PCN (Product Change Notice)

PCN Number: PCN_WL-SMSW_20250725

Affected Series: WL-SMSW

Before change

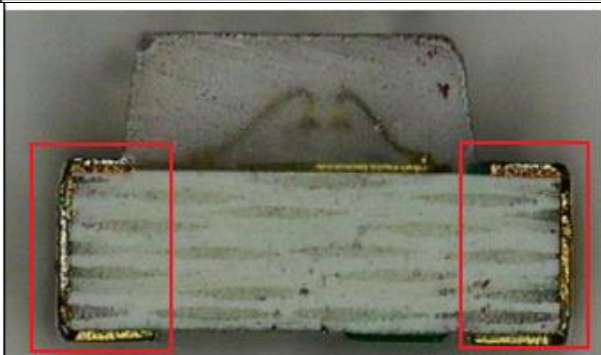
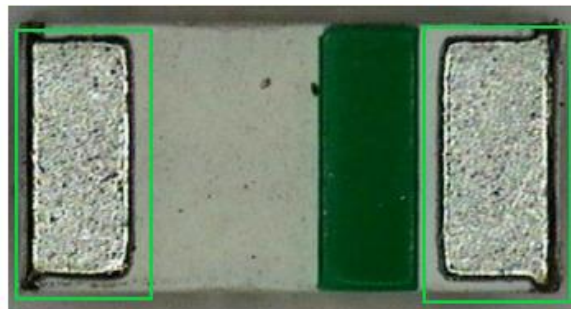
There are differences in the appearance before and after barrel plating, with a golden color before barrel plating and a silver color after barrel.
